Modifying the switched control box #883579 to operate as #882780 control box.

Before modification

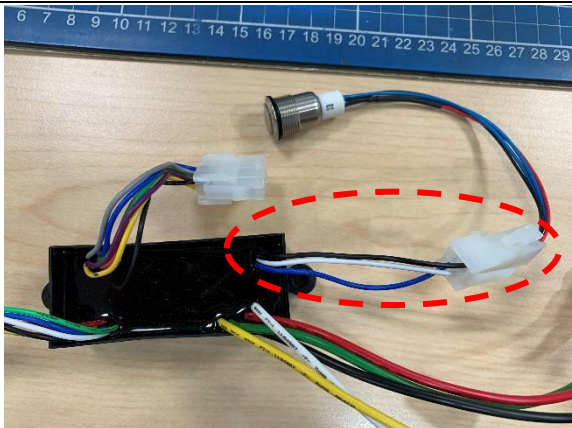
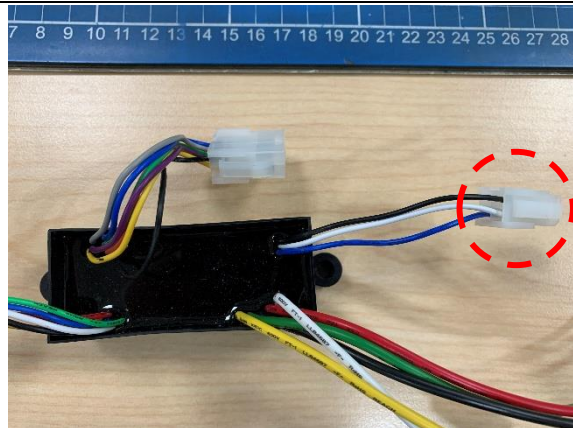
<ol style="list-style-type: none"> 1. Disconnect the On/Off switch by unplugging the connector shown in the red circle in the above left picture. 2. To modify to #882780, cut the wires entering the connector shown in the red circle in the above right picture. 	
After modification

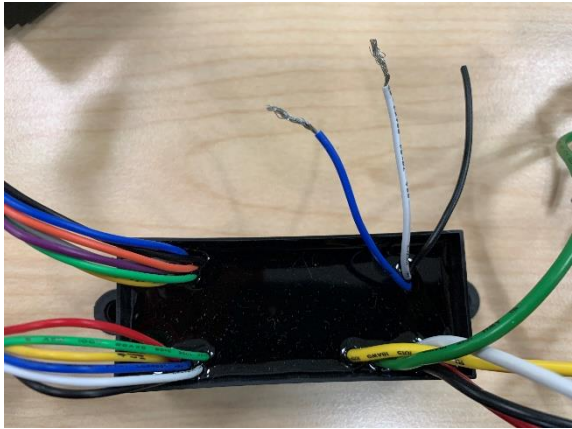
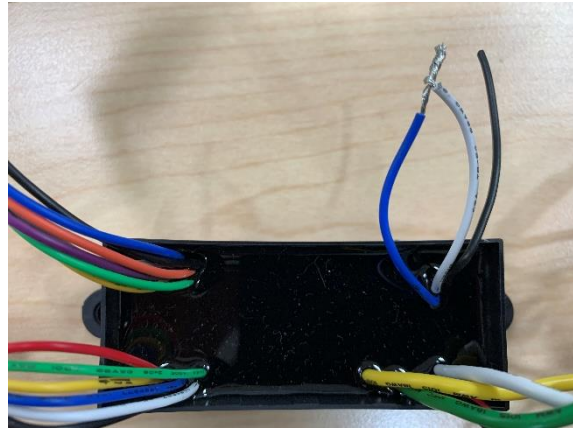
<ol style="list-style-type: none"> 1. Shown in the above left picture are the three wires, blue, white and black. 2. The blue and white wires are spliced together to power the wireless module. Complete the splice with protection added (heat shrink, butt connector, etc.) 	
<p>With the blue and white wires connected, the module is always powered, which is the same as #882780 control box. The module has a parasitic draw of about 0.25mA.</p>
